AAEON Technology INC.	
Title SoC CNVi	
Size	Document Number NANOCOM-TGU
Date:	Thursday, April 15, 2021
Sheet	11 of 34
Rev	A0.2_0_0

NANOCOM-TGU Revision History

NANOCOM-TGU A0.2_0_0 PCB: 1907NATU01 Date: 2021/03/10

XTAL 38.4MHz

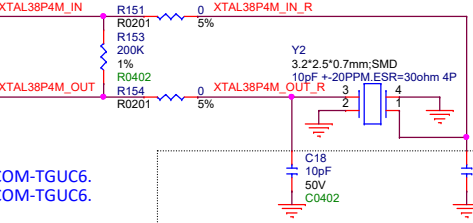
A02, 20210304 XTAL vendor suggestion & verification
Change C18/C19 from 15pF to 10pF.

SoC CNVi

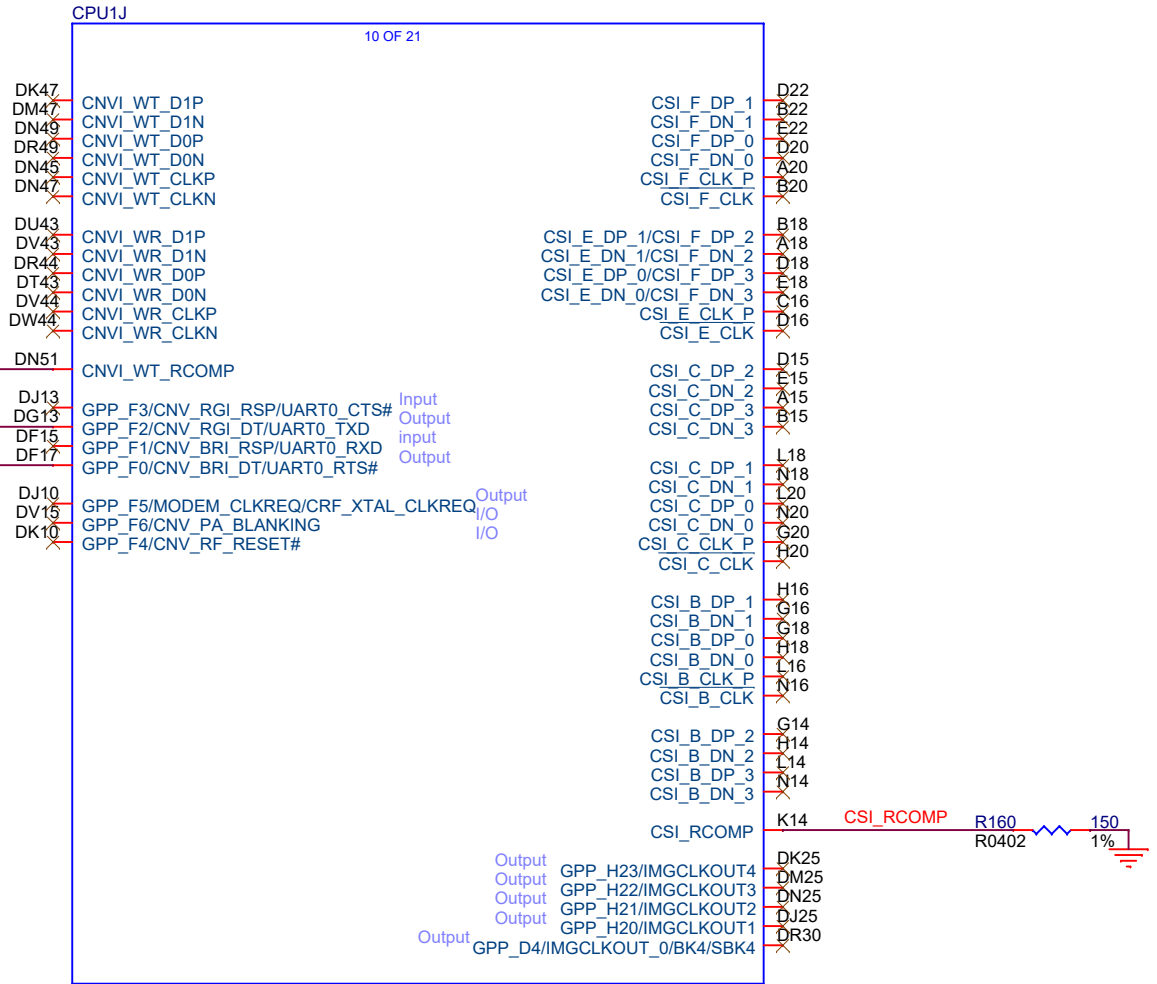
Remove reserve PU R, change to Test Point.

May change 0201
R158 4.7K **GPP_F2**
R0402 1%
Remove reserve PD R

LPDDR4x CHA

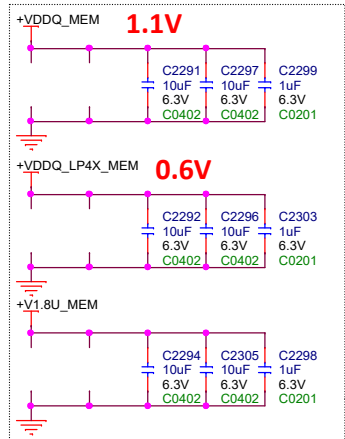
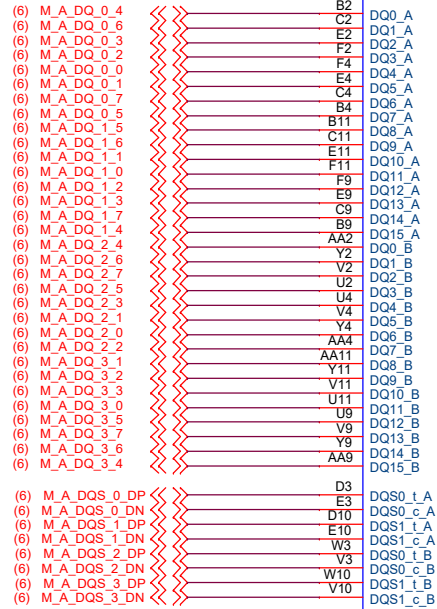
A02, 20210325 SWAP DQ cause re-routing DDR net.

20210324 Saving PCB space for DDR routing & follow PDG about the caps amount
Remove C2302/C2293 for +VDDQ_MEM.
Remove C2304/C2295 for +VDDQ_LP4X_MEM.
Remove C2301/C2300 for +V1.8U_MEM.

LPDDR4x CHB

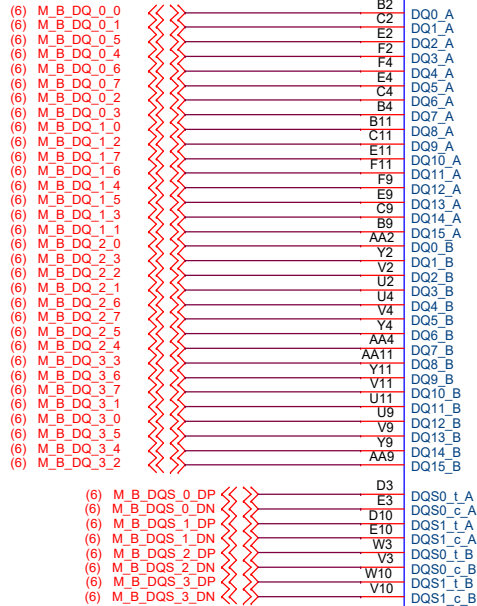
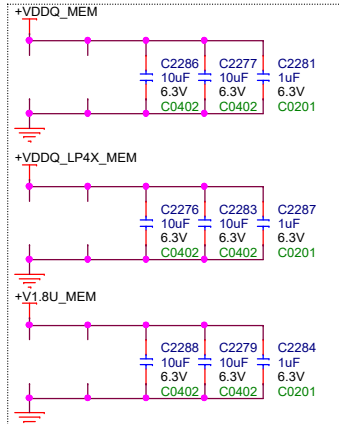
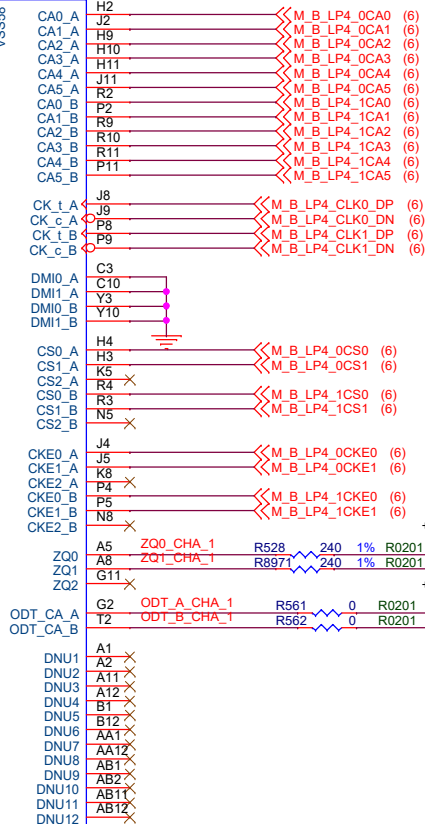
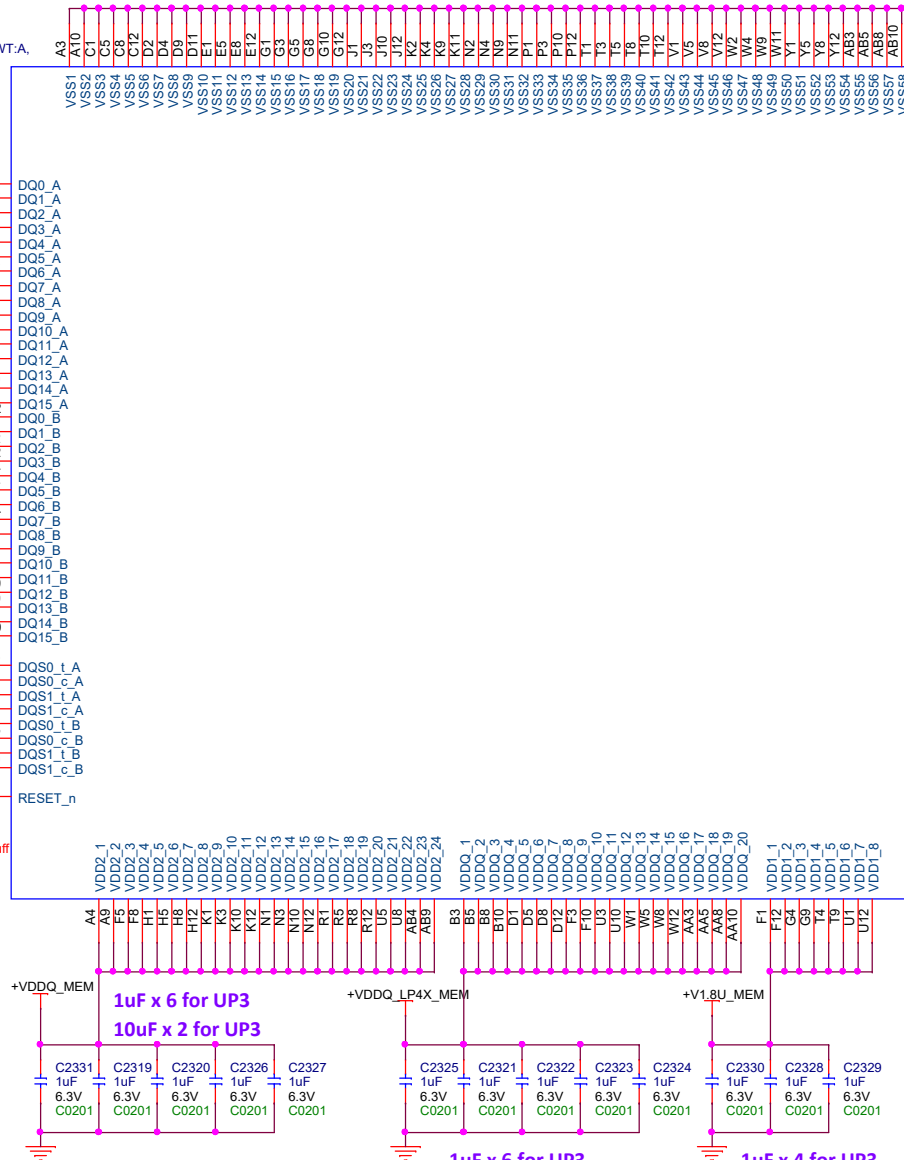
*Layout note:
Each 8 bits
swap by routing
A02, 20210325 SWAP DQ cause re-routing DDR net.

20210324 Saving PCB space for DDR routing & follow PDG about the caps amount
Remove C2282/C2289 for +VDDQ_MEM.
Remove C2280/C2290 for +VDDQ_LP4X_MEM.
Remove C2278/C2285 for +V1.8U_MEM.

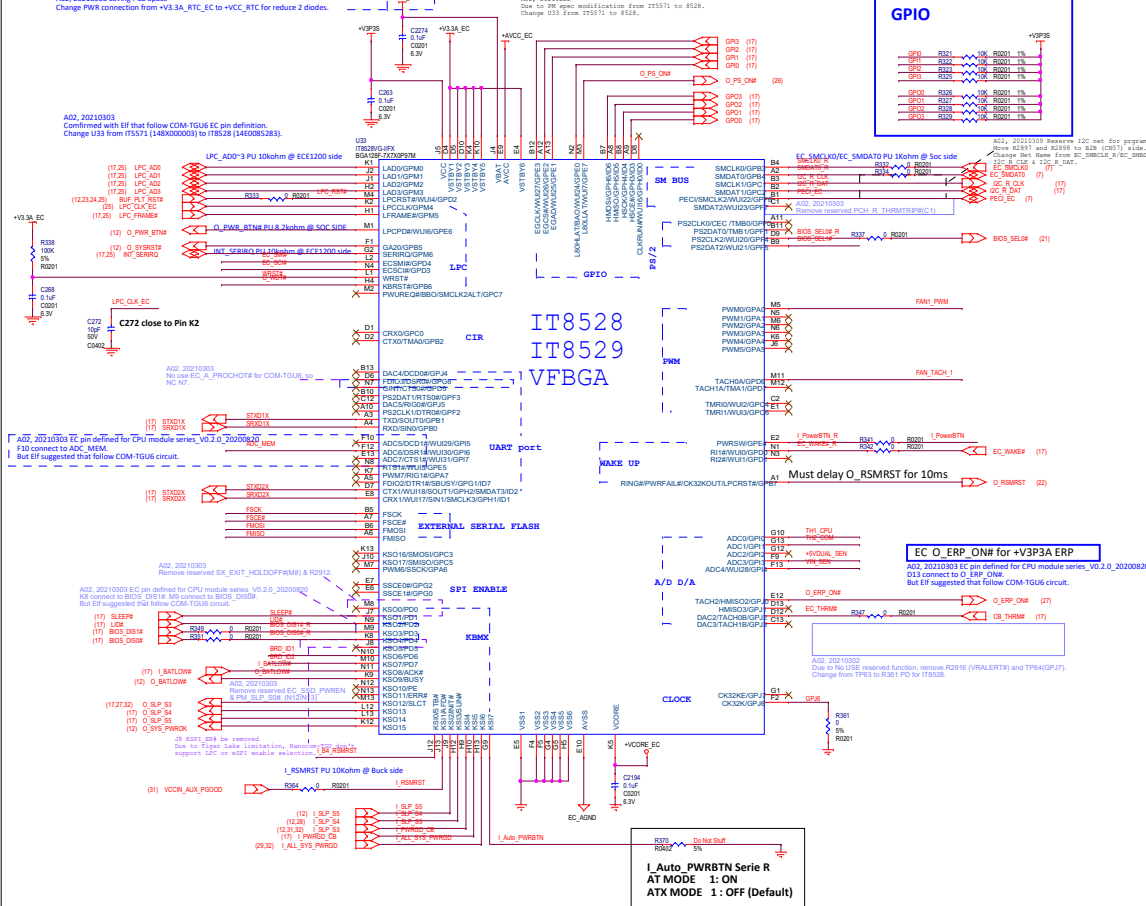
A02_20210303 Saving PCB Space
Change PWR connection from +V3.3A_RTC_EC to +VCC_RTC for reduce 2 pins.

A02_20210303
Confirmed with EIT that follow COM-TG06 EC pin definition.
Change U33 from IT5571 (148X000003) to IT8528 (1480B85283).

A02_20210222
Due to PM spec modification from IT5571 to 8528.
Add PWR pin circuit.

Tiger Lake IMVP9

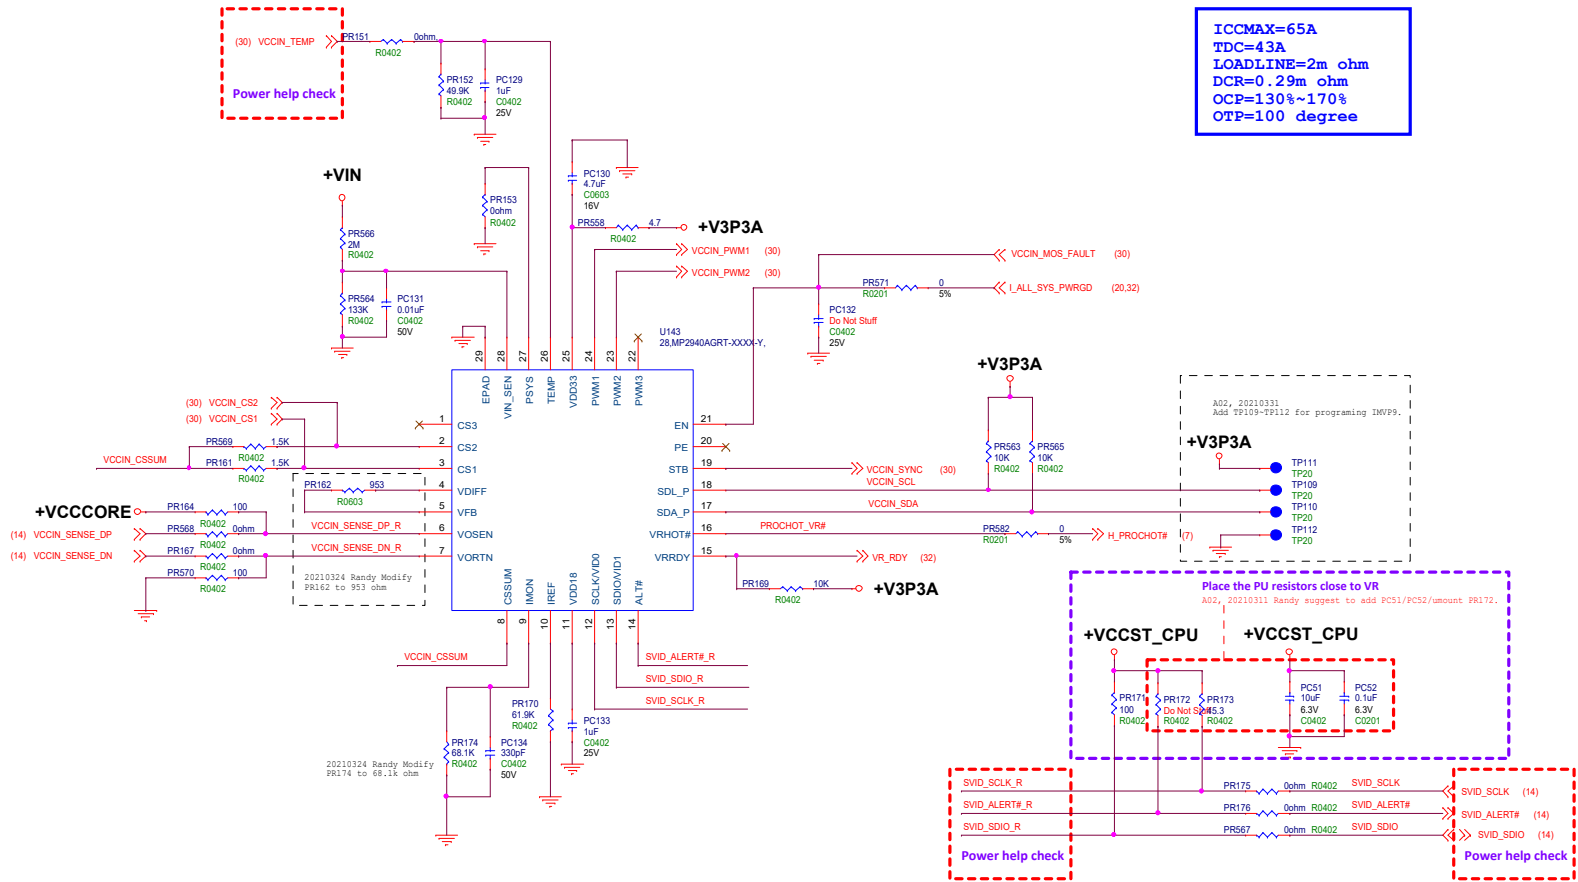
A02, 20210310 Saving PCB space
CUZ PM adding more spec modification, must narrow IMPV9 circuit (+VCCCORE) to saving more PCB space.
Remove whole IMPV9 circuit to add whole New IMPV9 circuit (PU30).

③ Title **RWP +VCCOPE**

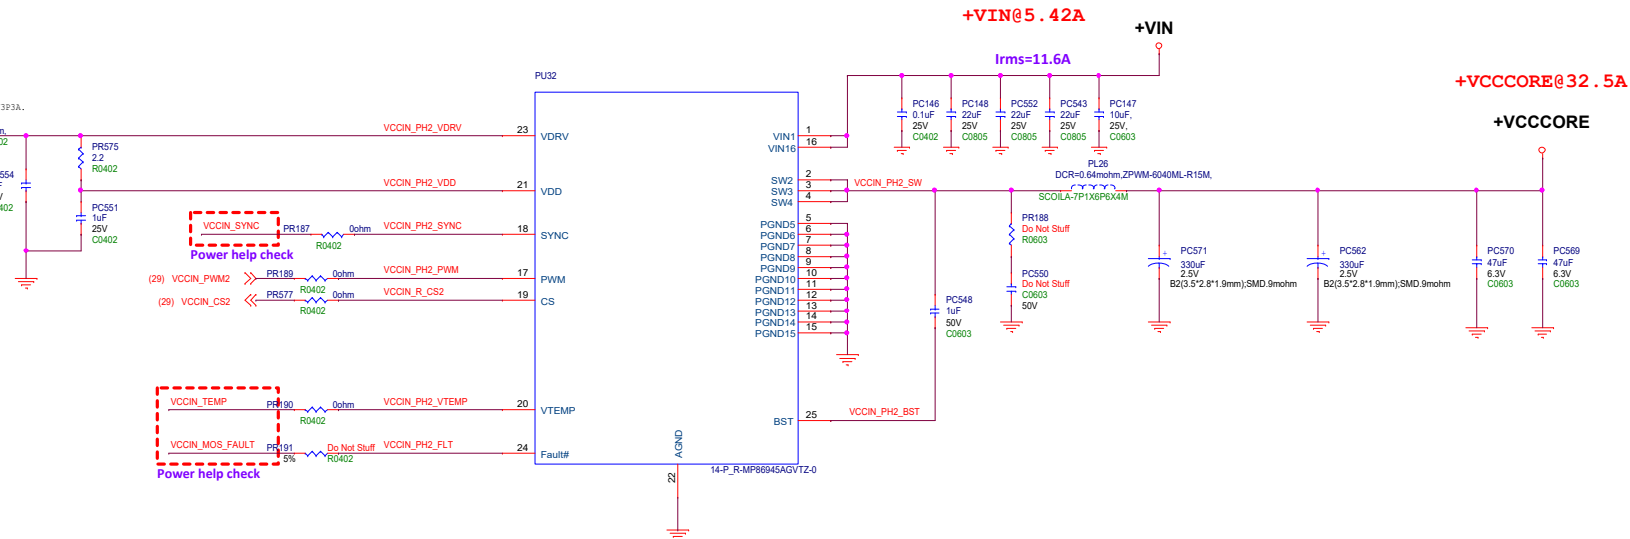
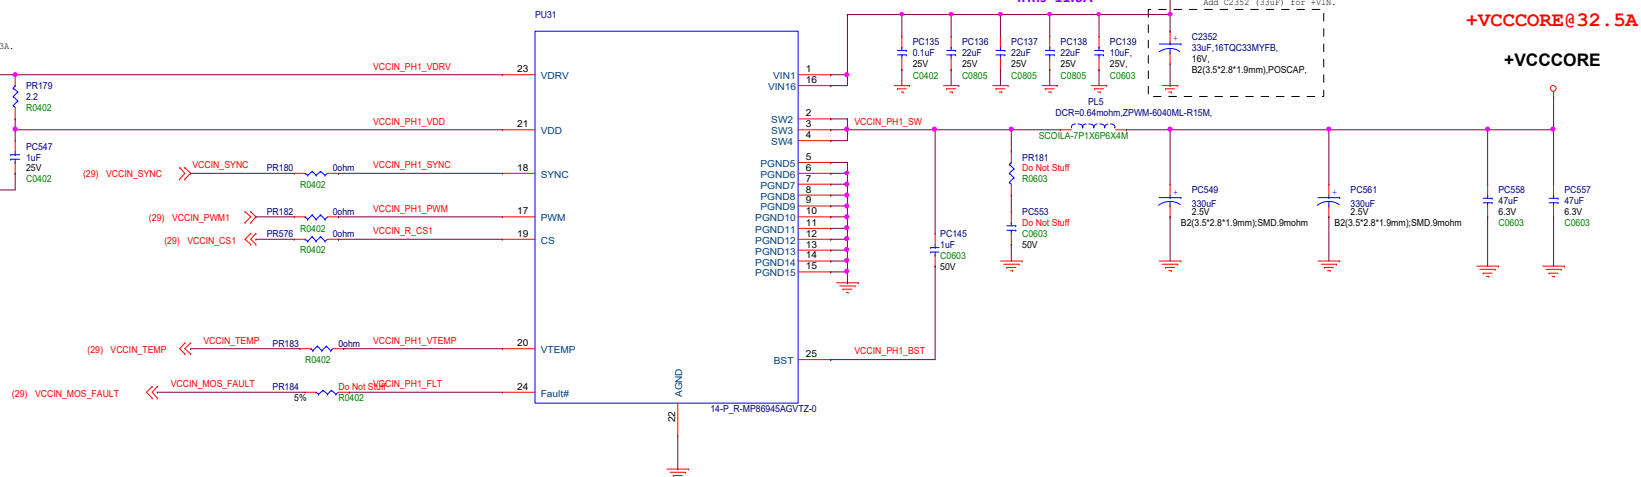
02, 20210323 Randy modify
change the PWR of PRL78 from +V5 DUAL to +V3P3A.

A02, 20210323 Randy modify
Change the PWR of PR178 from +V5_DUAL to +V3P3A.

+VCCIN_AUX

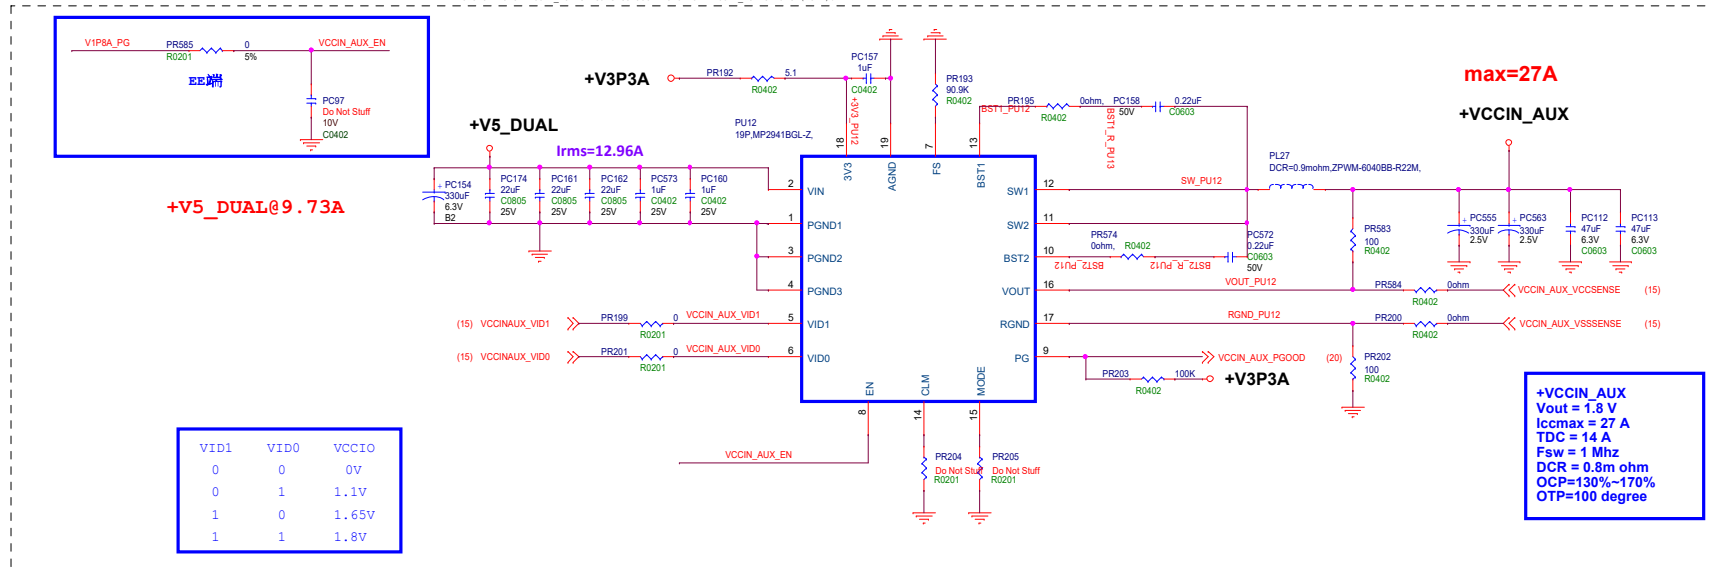
A02, 20210310 Saving PCB space
CU2 PM adding more spec modification, must narrow IMV99 circuit (+VCCIN_AUX) to saving more PCB space.
Remove whole +VCCIN_AUX circuit to add whole New +VCCIN_AUX circuit (PU12).

PCIe SSD 3* PWR supply

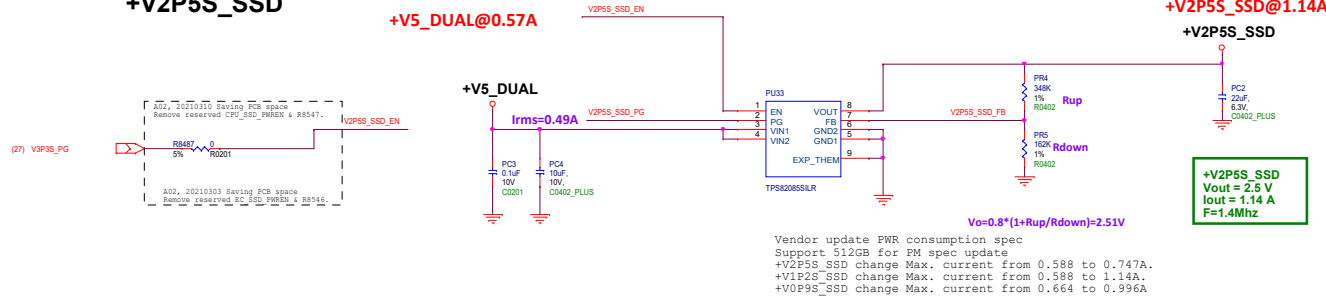
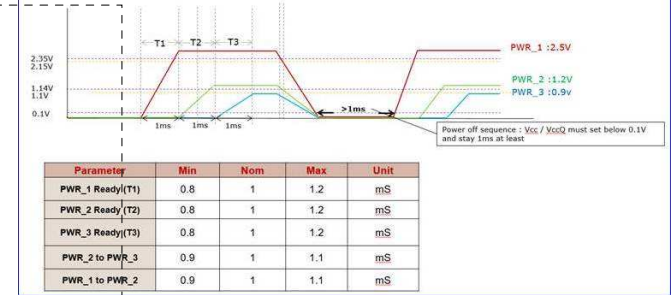
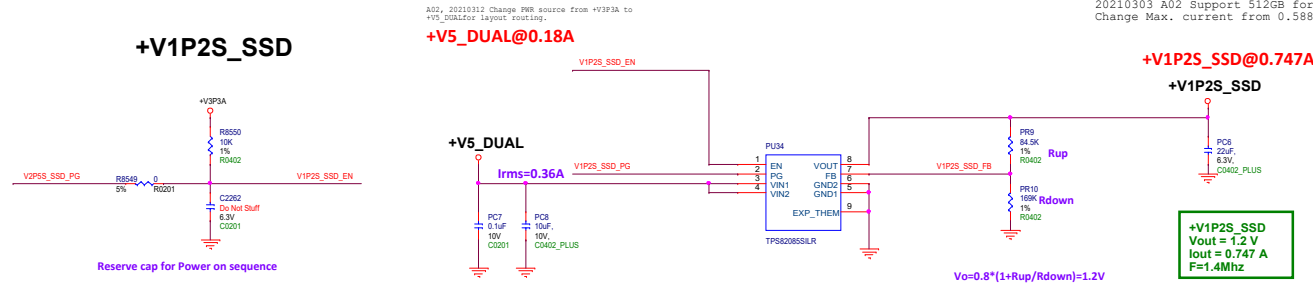
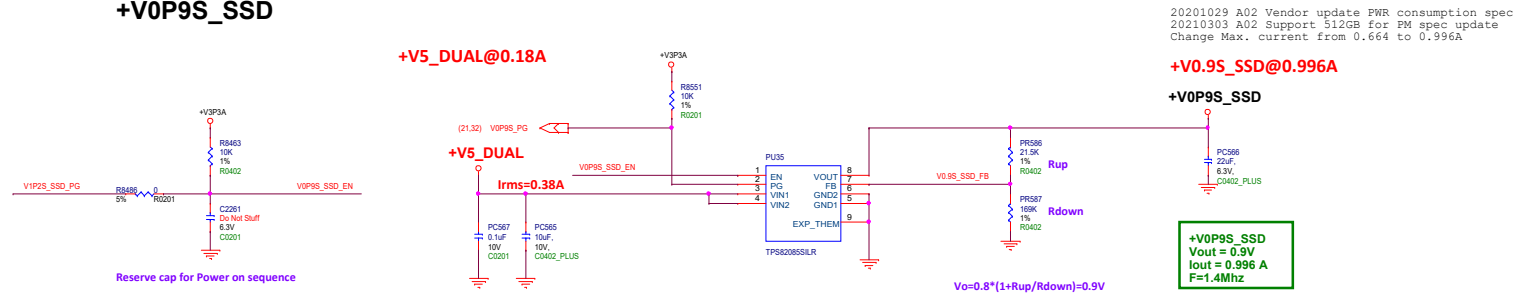
A02, 20210310 Saving PCB space
 C02 PM adding more space modification, must narrow 3 PCIe SSD PWR (2.5V/1.2V/0.9V) to saving more PCB space.
 Remove whole PCIe SSD PWR circuit to add whole New 3 * Buck circuits (PU33/PU34/PU35).

A02, 20210312 Change PWR source from +V3P3A to +V5_DUAL for layout routing.

20201029 A02 Vendor update PWR consumption spec
 20210303 A02 Support 512GB for PM spec update
 Change Max. current from 0.588 to 1.14A.
